APPENDIX "A"
to
REPORT COA2019-014
FILE NO. D20-2019-007

PROJECT:
**PROPOSED ADDITION/
ALTERATIONS TO EXISTING
GAS STATION**
7843 HWY 35 NORTH, CITY OF
KAWARTHA LAKES, ON

**Re: Proposed Gas Station, C-Store and Pizza Pizza - 7843 Highway 35N
Highway 35, City of Kawartha Lakes, Geog. Township of Laxton**

MTO has reviewed the updated site plan application package received on January 02, 2019 for the abovementioned development and offers the following comments.

1 SITE PLAN
A-1.0 SCALE: 1:200

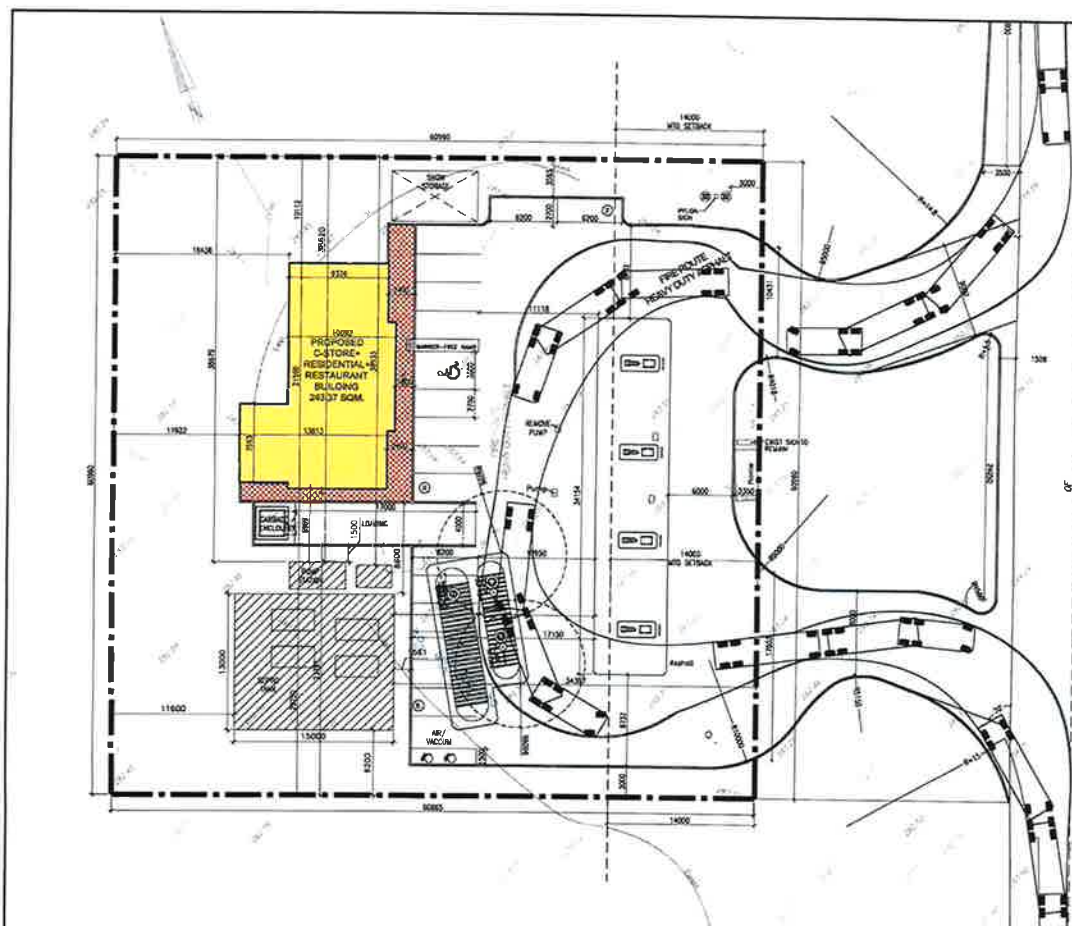
- The north and south proposed entrances into the property must meet MTO's current entrance standards. The entrances as depicted on the site plan/concept plan do not reflect MTO entrance standards and need to be corrected.
- The current commercial entrance standards can be found on MTO's Highway Corridor Management Manual, September 2018 – Chapter 4 - Access. The manual is available publicly through the MTO Library via the link at:
<https://www.library.mto.gov.on.ca/SydneyPLUS/Sydney/Portal/default.aspx?component=AAAIY&record=af9e17eb-ffc0-4143-b739-69af5835eb68>.
- All drawings completed for the Highway 35 right of way work, i.e. access, taper, left turn lane, etc. must be completed by a MTO RAQs approved consultant and be signed and stamped by the P. Eng.

- The site plan depicts a septic bed that is not located on this property parcel but appears that it might have serviced the previous site. Please confirm what this septic service is and will it be decommissioned?
- Where is the well located on the property? Note that MTO requires a 30 metre setback for wells from the property limit.
- There is an existing sign/planter that is shown will remain. MTO requires a minimum setback of 3 metres for all signs.
- A drawing of sign design will be required for the MTO sign permit.

Figure 1. DR-101 Overlay With Impervious Area Outlined (in blue)

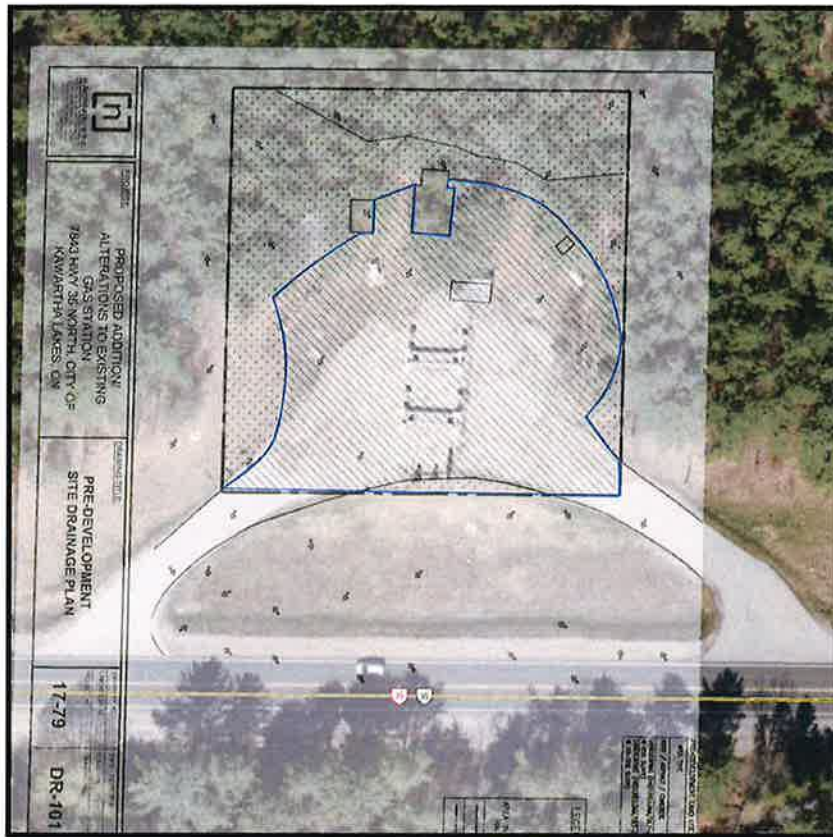
- The impervious area used to calculate the pre-development flows does not correlate to the actual site conditions, neither at present nor in the past (see Figures below). Since pre-development area is a foundational parameter for determining the runoff, error in this parameter renders rest of the calculations, conclusions, and controls based on it invalid.
